**1.3 1 WESTBROOK STREET, CHADSTONE
REMOVAL OF SEVEN (7) TREES IN A VEGETATION PROTECTION OVERLAY
(TPA/54189)**

EXECUTIVE SUMMARY:

The proposed removal of all seven (7) trees is considered inconsistent with the relevant provisions of the Monash Planning Scheme and it is recommended that a permit be granted to allow the removal of three (3) trees only (trees 1,2,6) and require the retention of four (4) trees (comprising of trees 3,7,8,10).

Attachment 1: 1 Westbrook Street, Chadstone

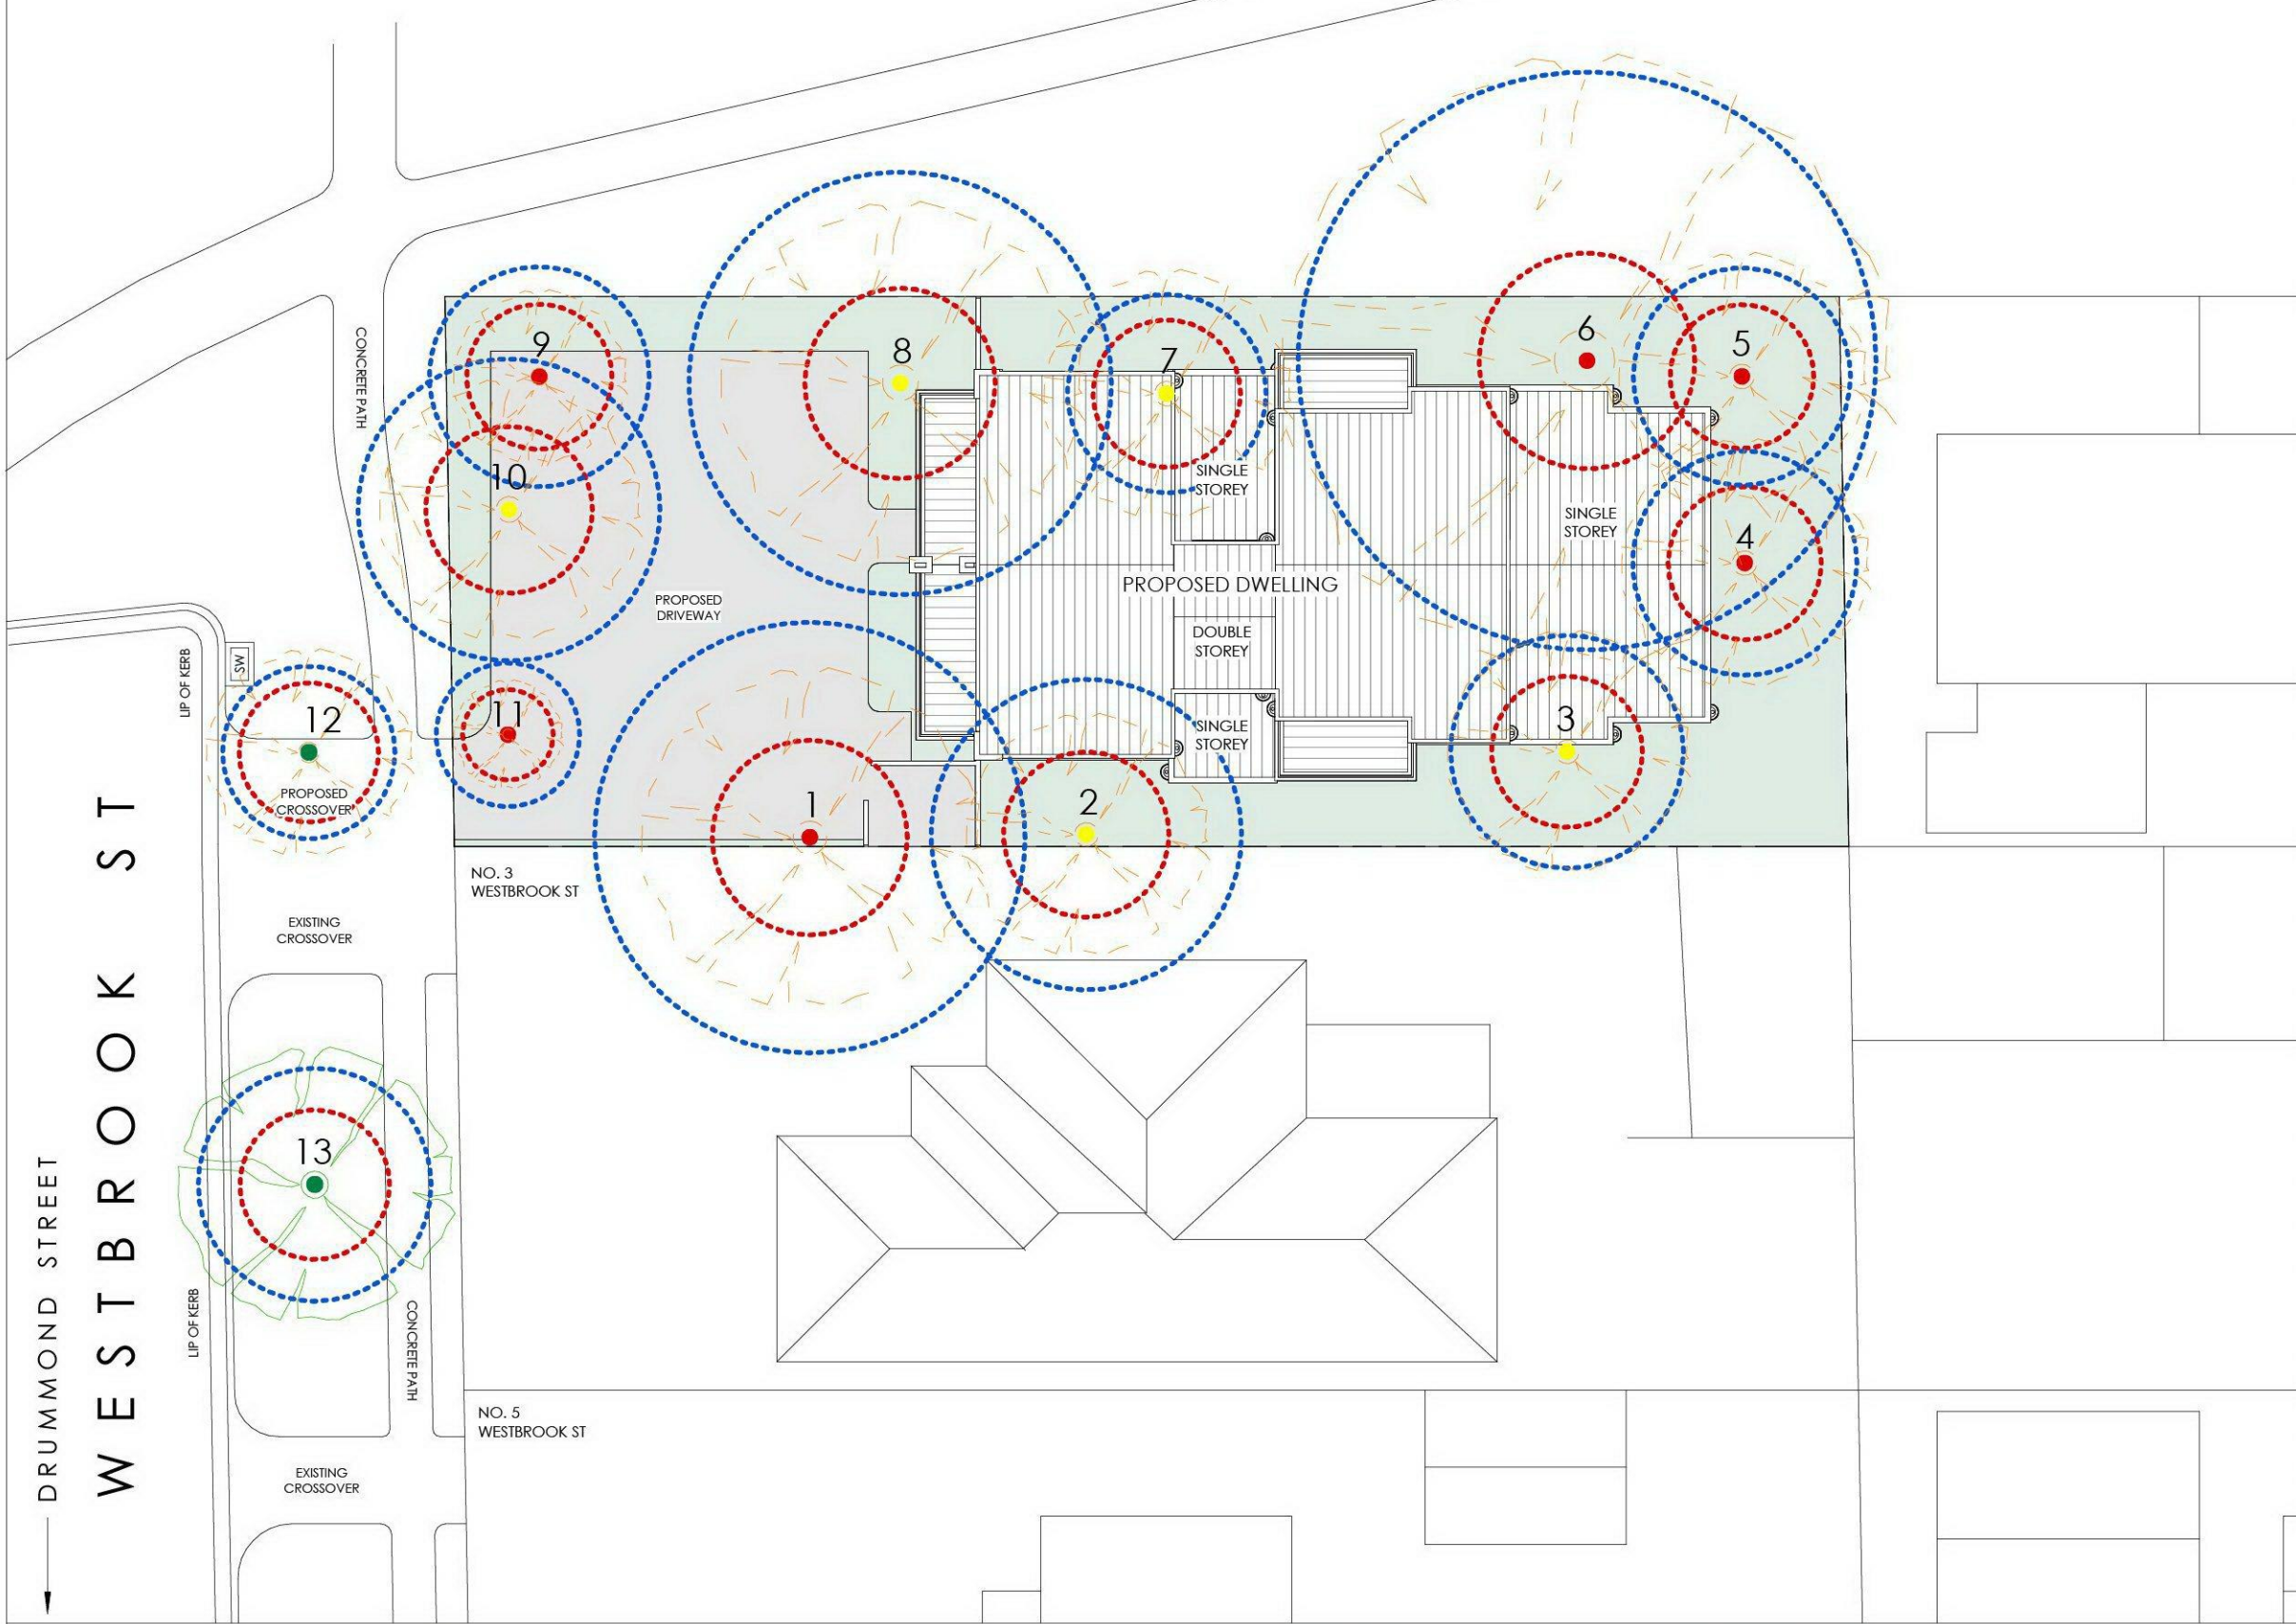
are recommended to be retained means that a design that better responds to these trees and the constraints they provide could see their retention. Whilst it is not for Council to design the dwelling for the land owner, it is considered that this is possible. Further, the removal of tree 10 which sits at the frontage of the site does not require a modified design of any proposed dwelling, rather the reduction of what is a significant paved driveway area as depicted on the plan submitted.

1. Before the removal of the subject trees, an amended plan to the satisfaction of the Responsible Authority must be submitted to and approved by the Responsible Authority. When approved, the plans will be endorsed and then form part of the Permit. The plans must be generally in accordance with the tree removal plan dated 11 August 2022 submitted to Council, but modified to show:

- a) All trees on site numbered according to the Arboricultural Report prepared by Melbourne Tree Care Pty Ltd.
- b) Trees 1 and 2 *Syzygium paniculatum* (Magenta Cherry Lilly Pilly) and Tree 6 *Eucalyptus nicholii* (Narrow-Leaved Black Peppermint) tree marked for removal only.
- c) Tree 3: *Eucalyptus saligna* (Sydney Blue Gum) tree, Tree 7: *Corymbia citriodora* (Lemon-scented Gum) tree, Tree 8: *Grevillea robusta* (Silky Oak) tree and Tree 10: *Corymbia maculata* (Spotted Gum) tree clearly identified to be retained.
- d) The location of Tree Protection Zones and Tree Protection Fencing as outlined within the Arborist Report prepared by Melbourne Tree Care Pty Ltd.

Tree ID	10	Origin	Vic. Native
Botanical Name	<i>Corymbia maculata</i>	Age	Semi mature
Common Name	Spotted Gum	DBH (cm)	35
Tree Height (m)	14	Canopy Spread (m)	6
Health	Fair	Structure	Fair
ULE	Medium	Location	Onsite
Observations

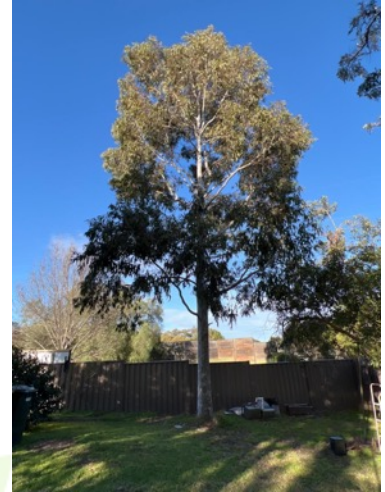
The Spotted Gum tree is located at the front of the site relatively close to the front boundary and is considered to contribute to the landscape character of the streetscape. Co-dominant stems were observed at 5 metres above ground level and there do not appear to be any wounds or included bark in the branch unions.

The independent Arborist observed that this tree included minor sooty mould to the lower leaves, which is a condition that can be treated and does not necessarily indicate that a tree is in decline.

Council considers that the tree canopy appears healthy and well-formed and if reduction pruning is carried out as recommended by Council's Arborist, the tree could continue to develop successfully with minimal risk to residents.
